STAFF REPORT ADDENDUM

SPECIAL PERMIT APPLICATION SP 2008-SP-088

WILLIAM C. AND DEBORAH VEALE

SPRINGFIELD DISTRICT

BIRD'S EYE VIEW OF ADDITION
SCALE 1/4" = 1'-0"

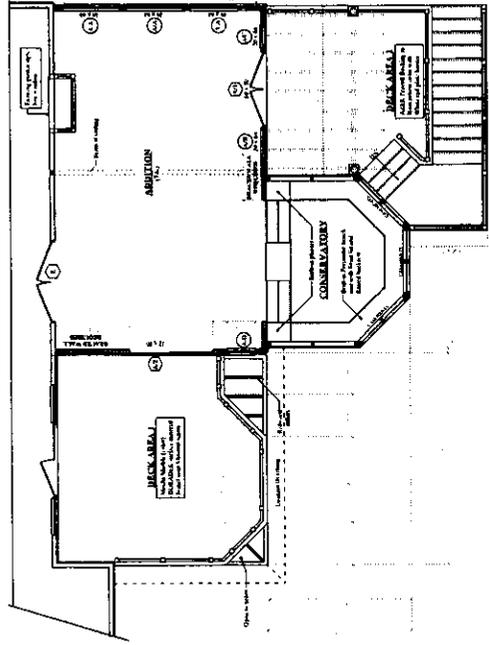
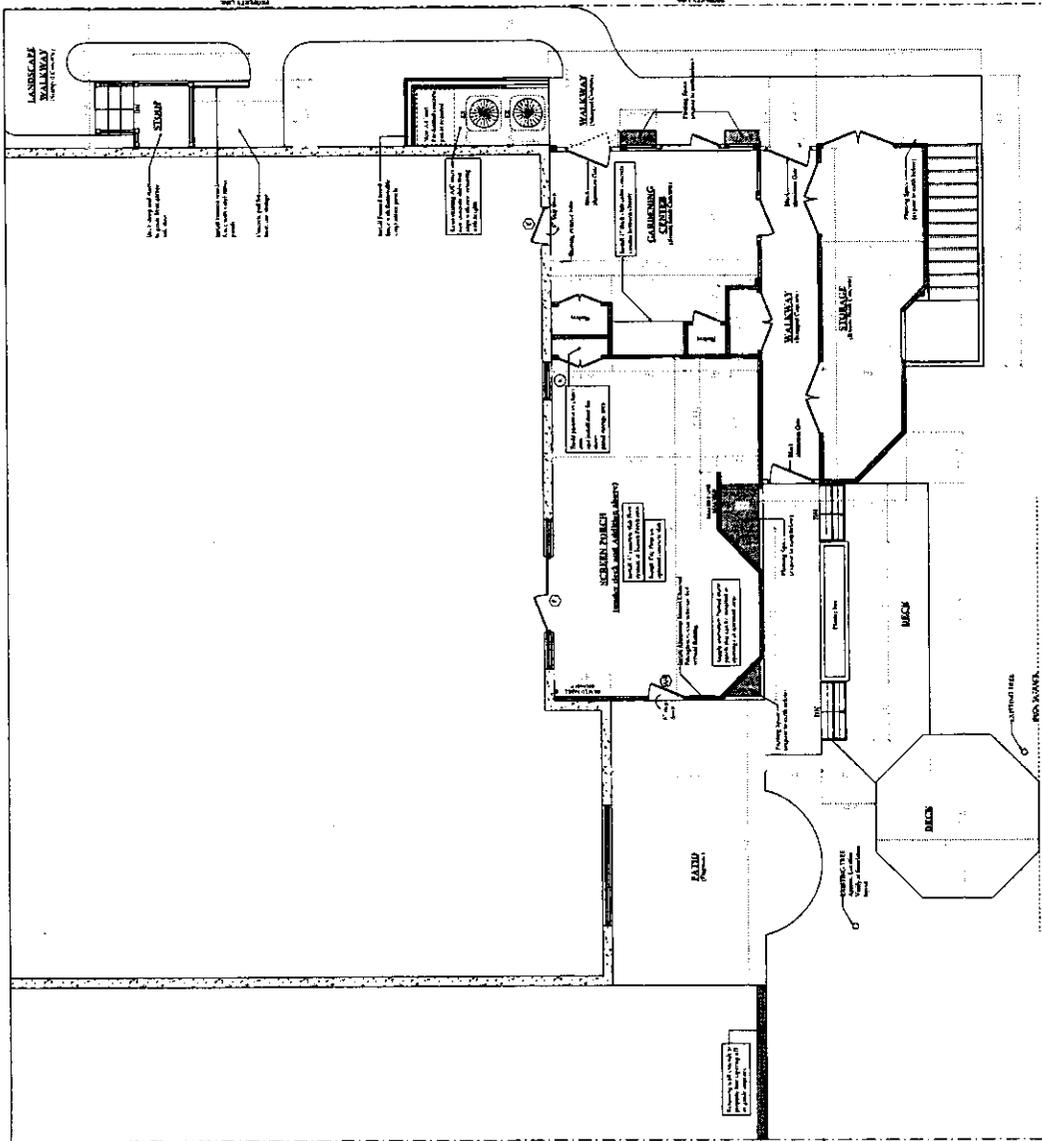
1. The size and scope of the structure, though large, is approved in this case because it backs to Parkland. Approval is based on modifications made to original plan that include making patio smaller (removal of hexagonal patio) and making stairs/deck not protrude from the side of house.
2. The walkway on the side of house is approved if it comes in from the property line 1 foot. This deviation from the guidelines is approved in this case because there is 10 feet of drainage common area between that property line and the neighbor's property line.
3. The green patina roof is approved. The Board looked at alternatives and feels this roof is the best aesthetic choice and will coordinate with the existing roof's shingles and the existing copper on the house. Also noted in the approval is that roof is not visible from the street.

4. The pickets in the railings must all be consistent (either white or black) for approval. The Board does not approve one deck with white pickets and one deck with black pickets. The Board approves the choice of either white or black for all pickets in this case because the house has white trim and black shutters, so both colors would coordinate with existing colors on the house.

5. The Board does not approve the trash can structure behind the stoop on the side of the house because this was not included in the application to the ARC. This is a new change not previously considered by the ARC. As noted, the screening of the air conditioning units and the stoop for the side door of the garage are approved. Please note that in general, others structures on the side of the house are not in keeping with Barrington HOA Architectural Guidelines.

4. The addition shall be consistent with the architectural renderings and materials included in Attachment 1 to these conditions.

SPECIAL PERMIT PLAT
LOT 246
SECTION 6
BARRINGTON
SPRINGFIELD DISTRICT
FAIRFAX COUNTY, VIRGINIA

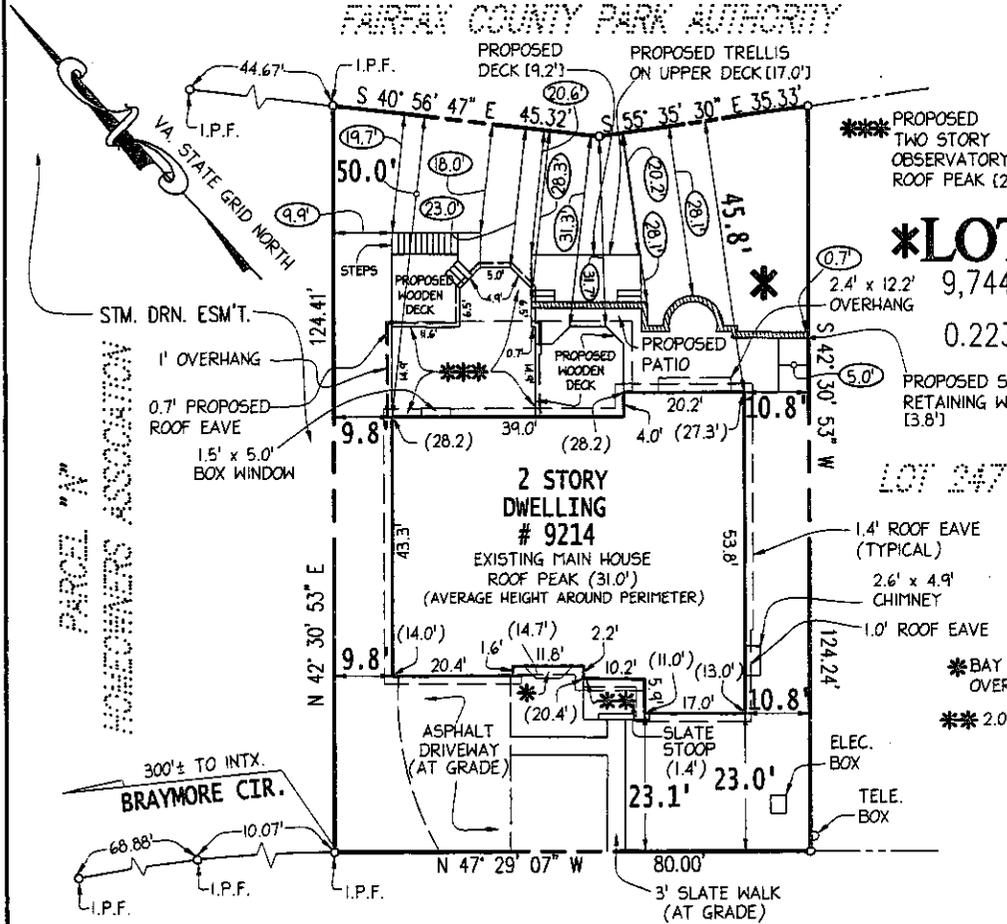
The applicant has redesigned the proposed one story addition and is now seeking approval of a special permit for the reduction of certain yard requirements to permit the construction of the two story addition still 23 feet from the rear lot line and construction

of the one story addition 18 feet from the rear lot line and side yards totaling 20.6 feet. This revised proposal differs from the previous request because the one story addition was modified to no longer encroach further into the western side yard than the existing dwelling per staff's recommendation. The previous request proposed the one story addition 5 feet from the western side lot line. The applicant shortened the encroachment of the addition into the side yard by 4.9 feet.

Staff believes that the revised request shown on the plat included as Attachment 3 to the Addendum, dated and revised through March 18, 2009, is in conformance with all applicable Zoning Ordinance provisions as noted above in that the location on site of the one story addition no longer compromises the character of the surrounding neighborhood by reducing the intrusion into the side yard.

2. This special permit is approved for the location and size of the proposed two story addition (conservancy with storage below) as shown on the plat prepared Timothy D. Farrell, B.W. Smith and Associates, inc., dated April 1, 2008, revised through ~~December 18, 2008~~ March 18, 2009 submitted with this application and is not transferable to other land.
